WOODBIDGE PARK JSP 17-67

Public hearing at the request of Pulte Homes of Michigan, LLC for Preliminary Site Plan, Wetland Permit, Woodland Permit, and Storm Water Management plan approval. The subject property is currently zoned RM-1 (Low-rise Multiple Family Residential). The subject property is approximately 9.23 acres and is located at the northeast corner of Novi Road and Nine Mile Road (Section 26). The applicant is proposing a 40-unit multi-family for-sale residential development with frontage and access to Nine Mile Road.

PLANNING REVIEW

WETLANDS REVIEW

PULTE HOMES OF MICHIGAN, LLC
WOODBRIDGE PARK
PRELIMINARY SITE PLAN
LAYOUT PLAN

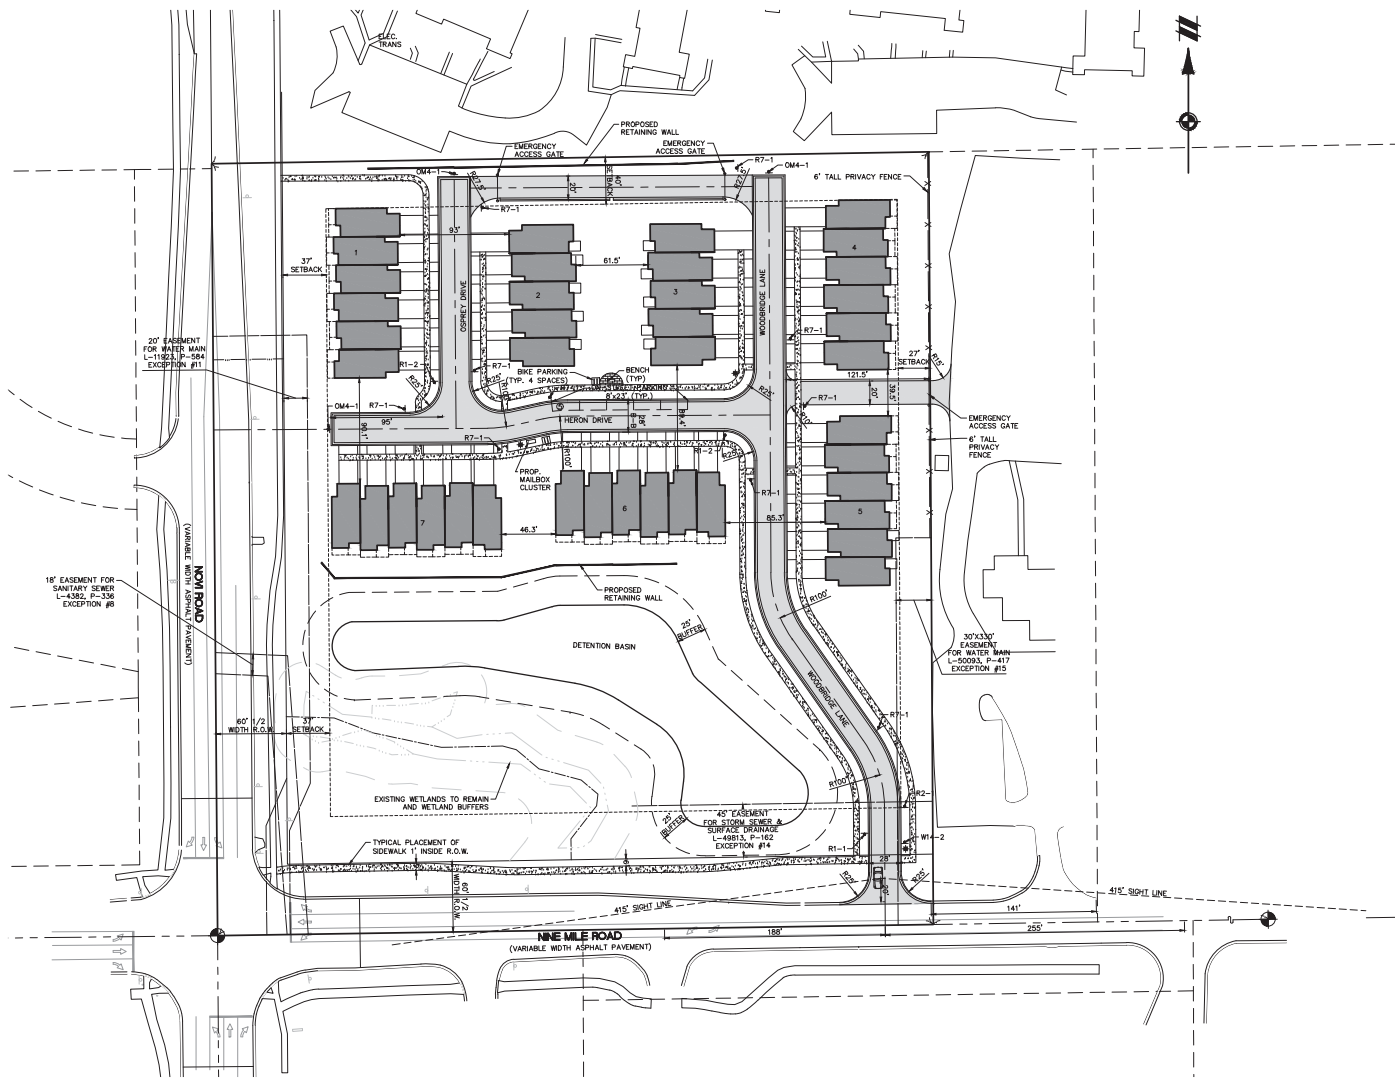
2. **Mailbox Parking:** The applicant has designated 5 spaces north of Heron drive for mailbox parking. The proposed location is acceptable, but **the applicant should refine the signing plans to clearly label that as an approved parking zone, since the remainder of their site prohibits on-street parking.**

We do not recommend striping the parking spaces on street. Propose a sign on the east end of the parking “bay” to begin the permitted parking section. Signs similar to the following could be considered at either end of the parking area with arrows pointing in opposite, applicable directions or replace the arrow symbol on the signs with “THIS SIDE OF SIGN” or “HERE TO CORNER” at beginning and end of the parking bay, respectively.

- d. The City requires one bicycle parking space every five units totaling nine bicycle parking spaces. The applicant is proposing 10 bicycle parking spaces according to the cover sheet and 12 bicycle parking spaces according to the plans. The applicant should revise the plans for consistency.

- d. The City requires one bicycle parking space every five units totaling nine bicycle parking spaces. The applicant is proposing 10 bicycle parking spaces according to the cover sheet and 12 bicycle parking spaces according to the plans. The applicant should revise the plans for consistency.

Response: *Per City request, the street signage and layout presentation has been revised to allow additional street parking on the north side of Heron Circle near the mailbox cluster and pocket park areas. Refer to sheet 05.*

Response: *The two stop signs have been changed to yield signs (R1-2) per request. Refer to sheet 05.*
 - b. The applicant should provide R7-1 signs on both sides of the street if on-street parking is to be dis-allowed.

Response: *No parking signs have been added to both sides of the street in the areas on-street parking will be dis-allowed. The street signage and layout presentation has been revised to allow additional street parking on the north side of Heron Circle near the mailbox cluster and pocket park areas. Refer to sheet 05.*

Response: *A speed limit (R2-1) sign has been added at the entrance of the development as requested. Refer to sheet 05.*
 - f. The applicant is required to provide an OM4 series (end of roadway: OM4-1, OM4-2, or OM4-3) sign at each of the three dead ends.

Response: *OM4-1 signs have been added at the end of the three dead end roads. Refer to sheet 05.*
 - g. The applicant should include D3-1 (street name) signs in future submittals. Street name signs have the following requirements:

PULTE HOMES OF MICHIGAN, LLC
 WOODBRIDGE PARK
 PRELIMINARY SITE PLAN
 LANDSCAPE PLAN

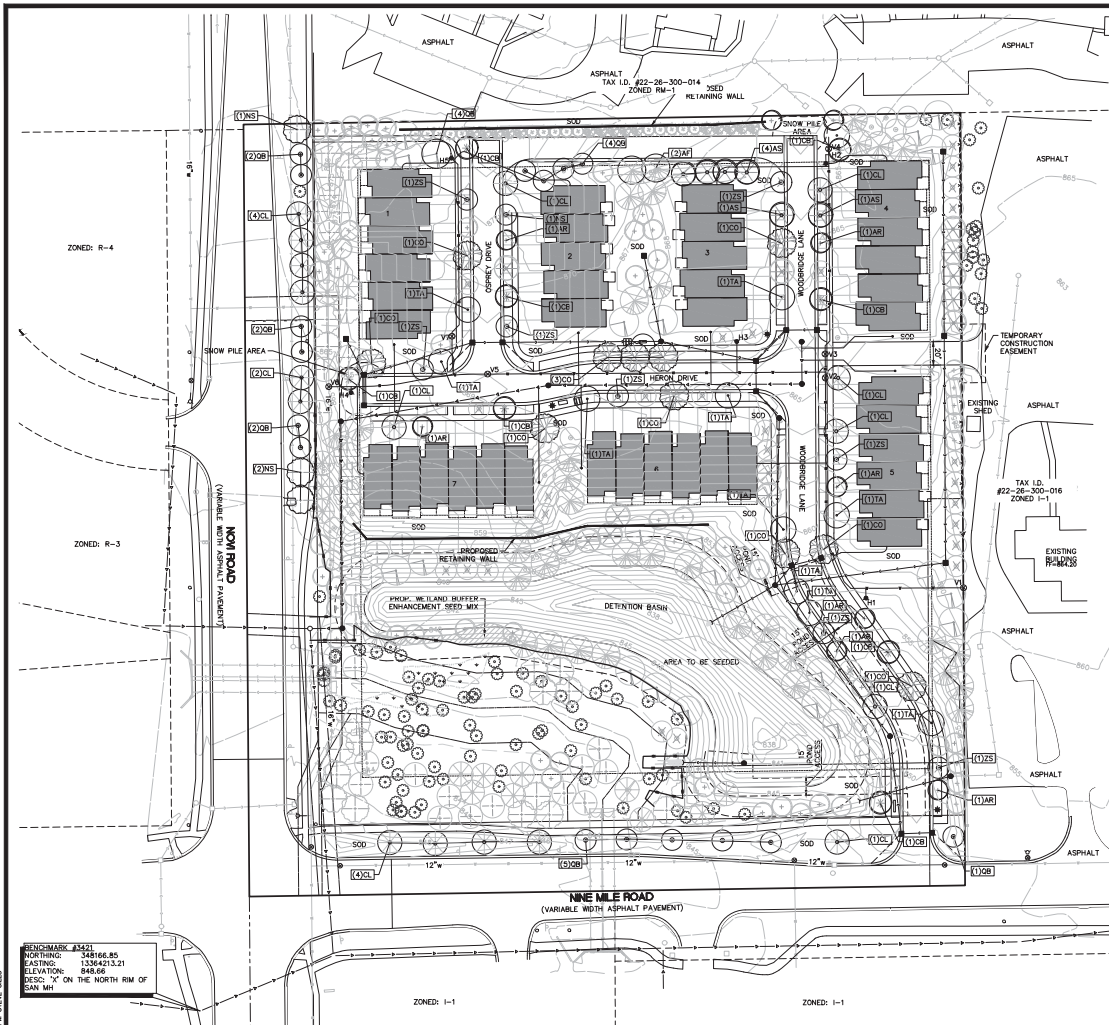
1. **Lighting and Photometric Plan:** Please show the light poles on the landscape plan to make sure that there are no conflicts with proposed tree locations.
2. **Wetland and Woodland Conservation Easements:** Draft of conservation easement are required prior to stamping set submittal.

It should be noted that the *Landscape Plan* (Sheet 09) indicates that a total of 282 Woodland Replacement Tree credits are required for the proposed tree removals. The Plan does not appear to clearly indicate which tree material is intended to meet the Woodland Replacement Tree requirements. This information shall be clearly indicated on the Plan.

Response: *The tree species intended to be woodland replacement trees are now indicated in the master plant list on sheet 12.*

Figure 1. City of Novi Regulated Wetland & Woodland GIS Coverage Map (approximate property boundary shown in red). Regulated Woodland areas are shown in green and regulated Wetland areas are shown in blue.

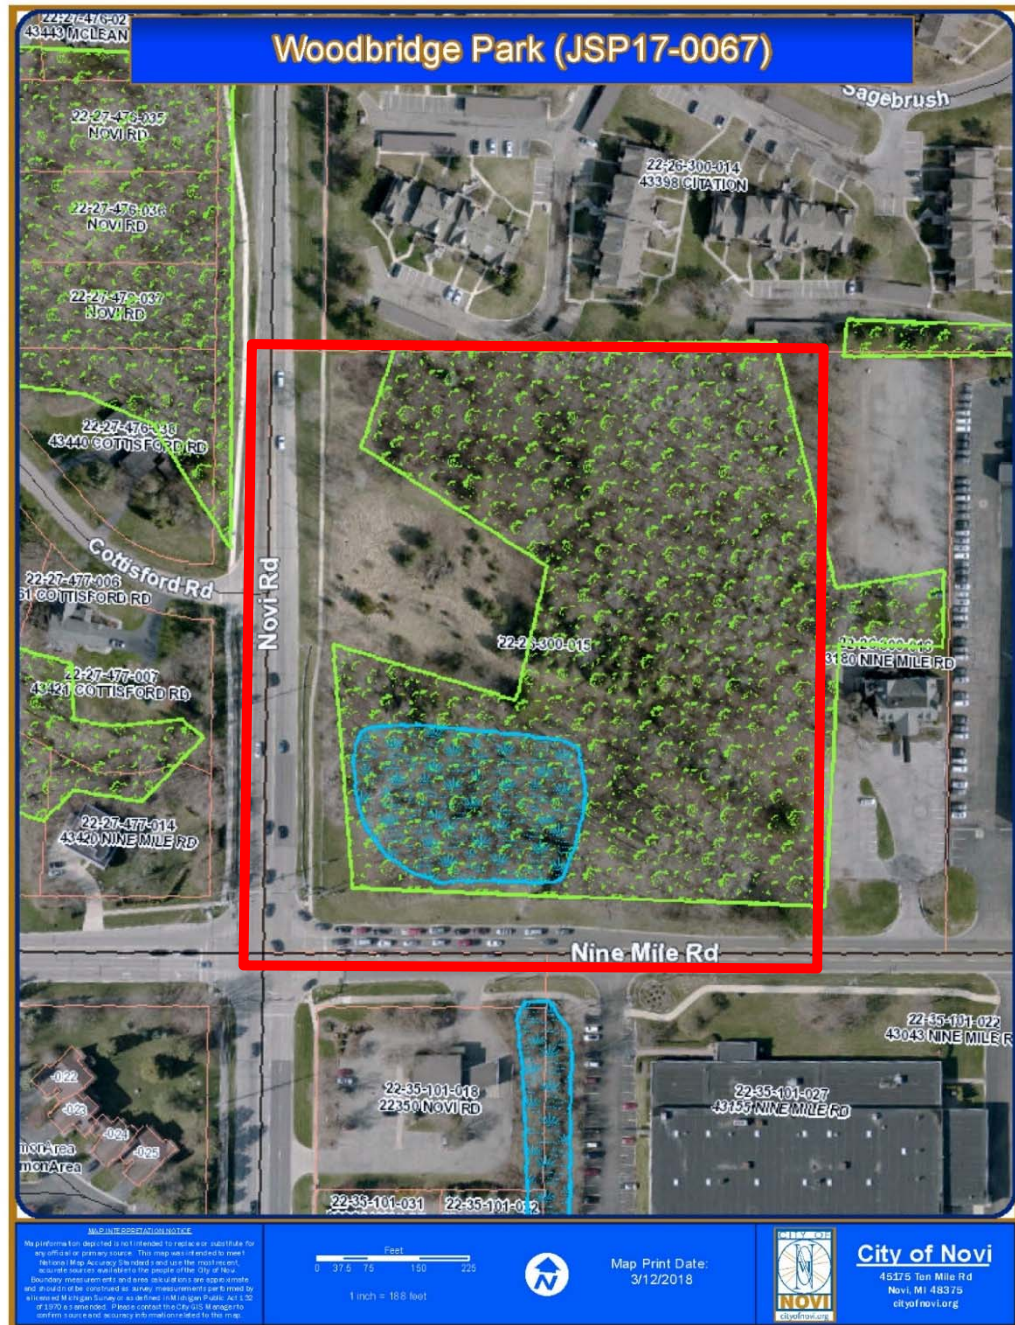
Based on our review of the Plan, Novi aerial photos, Novi GIS, and the City of Novi Official Wetlands and Woodlands Maps (see Figure 1); it appears as if this proposed project site contains both City-Regulated Wetlands and Regulated Woodlands. In addition, Thornton Creek flows through the southwestern portion of the project site.

Although the acreage of the site containing areas mapped as City-Regulated Woodland does not appear to be quantified on the Plan, the proposed project site contains a significant amount of City-Regulated Woodland area (see Figure 1).

ECT's in-office review of available materials included the City of Novi Regulated Woodland map and historical aerial photographs. The site includes areas indicated as City-regulated woodland on the official City of Novi Regulated Woodland Map (see Figure 1).
